MANUAL CHANGE INFORMATION FOR MODEL BWD 820

BWD INSTRUMENTS PTY. LTD.

FROM SERIAL NO.	ISSUE	DATE	FROM SERIAL NO.	ISSUE	DATE
44774	2	8.4.80			
45524	3	12.5.80			
44774	4	17.7.80

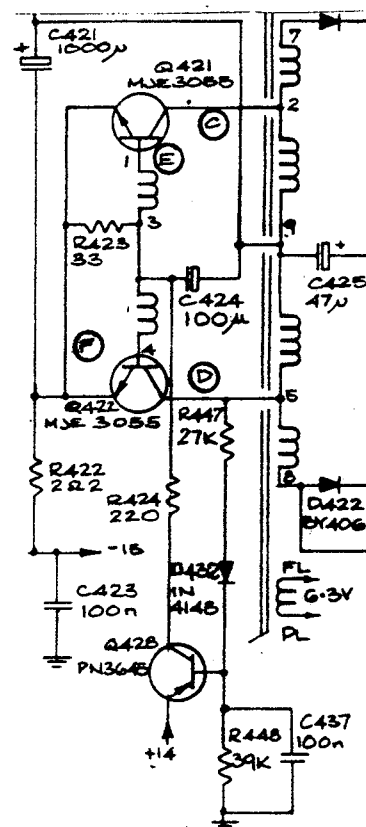
Issue	Sect.	Page	Cct.	AMENDMENT
5	11	12	1561	D103 & 104 added.
6	11	12	1561	D105 added.
6	11	1 & 2	1561	R123 was 1W.
6	11	3	1562	R300 added.
6	5	0		117V & 235V nominal added to transformer diagram.
6	11	8		Full Part No. added to C315 & C316D.
6	11	10		Note added. Q201 & 204 matched pair.
6	11	11		Note added. Q421 & 422 matched pair.
6	11	13		D221 parts list error, was FLV304.
6	11	14		Part No's added to S1, S2, S52, S57, S161, S301 & S303.
6	11	15		F401 Fuse size was 3AG.
6	11	5	1563	R449 added across base-emitter Q423.
6	11	13	1563	D406 & 7 added across + & -15V rails.
6	11	6	1560	C17 & C67 ADDED.
6	11	7 & 8	1562	C302 Moved. C325 Added.
6	11	5	1562	R360 Added.
6	8	4		Para 12. Add 'C325' after via end of line 2.
				Para 12. Remove 'AC coupled via C302' and insert 'applied' in line 4.
7	All	All	All	Handbook upgraded.
8	11	5, 9, 11, 13	1563	Q428, C437, D432, R447 and R448 removed. R424 changed to 4k7 1W and taken to +14V as starting circuit not needed when D433 is added in series with R423.

NOTE: CH1 shown, CH2 similar.

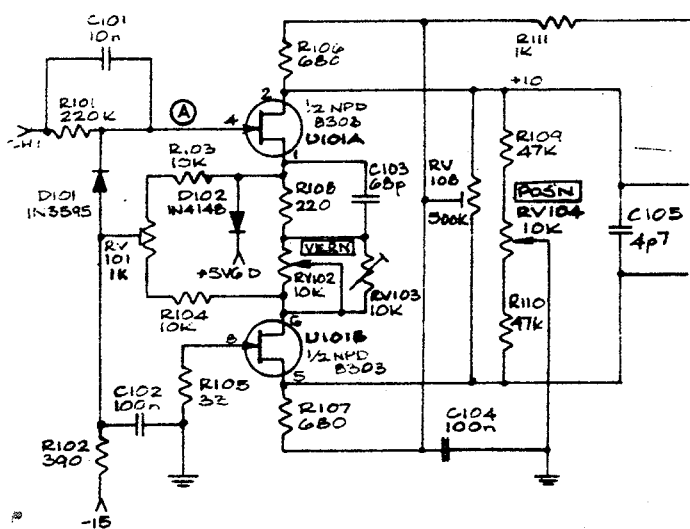
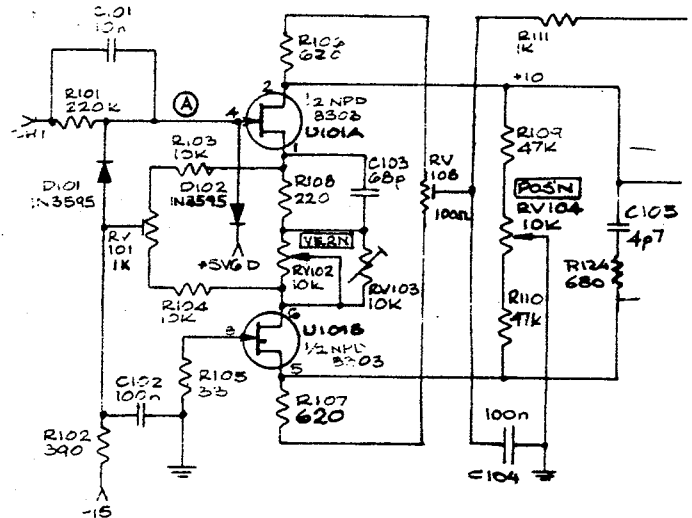
Issue	Sect.	Page	Cct.	AMENDMENT
8				Main PCB No. 160-313D
8	11	9	1561	RV108 & RV138 changed from 500K.
8	11	12	1561	D102 was IN4148.
8	11	12	1561	D132 was IN4148.
8	11	1 & 2	1561	R106, R107, R136 & R137 were 680Ω.
8	11	2	1561	R124 & R154 ADDED in series with C105 & C135.

Circuit applicable up to
Serial No. 47040Circuit applicable from
Serial No. 47041
